# Access Compliance Report

## Public Rights-of-Way

Intersection ID: 20385	Main Street: COOPERSDALE_RD	Cross Street: INGLEHURST_DR	Location: NW
ADA ID: CCC361A5D95F	Ramp Type: Directional1	Initial Pass/Fail: Fail	Overall Compliance: No
Severity Score: 10			
Codes/Mitigation Info/Possible Solution		Field Measurements/Component Compliance

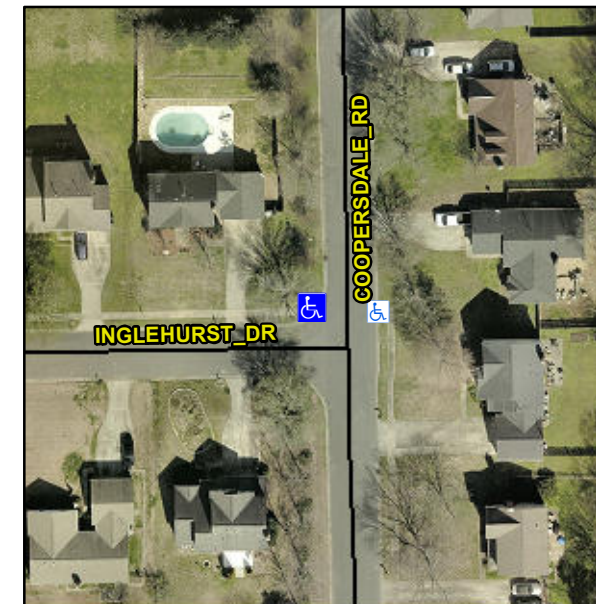
**Remove & Replace Entire Ramp.**

**R304.5.1, R304.5.3**

Compliance	Description	Data	Compliance	Description	Data
N/A	Ramp Length (in)	67.0	N/A	Grade Break?	N/A
No	Ramp Width (in)	40.0	N/A	Grade Break Slope (%)	0.0
Yes	Ramp Slope (%)	3.2	N/A	Grade Break XSlope (%)	0.0
No	Ramp XSlope (%)	3.6			
N/A	Flare Type LT	N/A	N/A	Flare Type RT	N/A
N/A	Flare Slope LT (%)	N/A	N/A	Flare Slope RT (%)	0.0
N/A	Flare Traversable LT?	N/A	N/A	Flare Traversable RT?	N/A
N/A	Landing Length (in)	0.0	N/A	DWS Provided?	N/A
N/A	Landing Width (in)	0.0	N/A	DWS Contrast?	N/A
N/A	Landing Slope (%)	0.0	N/A	DWS Length (in)	N/A
N/A	Landing X Slope (%)	0.0	N/A	DWS Full Width?	N/A
N/A	Landing Curb? (Y/N)	N/A	N/A	DWS Offset LT (in)	N/A
N/A	Shared Landing?	N/A	N/A	DWS Offset RT (in)	N/A
N/A	Gutter Ponding?	0.0	N/A	Gutter Slope (%)	N/A
N/A	Gutter Lip Ht (in)	0.0	N/A	Gutter X Slope (%)	N/A
N/A	Painted X Walk1?	No		Road Slope (%)	0.3
	X Walk 1 Direction	To SE		Road X Slope (%)	2.3
	X Walk 1 Width (in)	N/A		Clear Space?	N/A
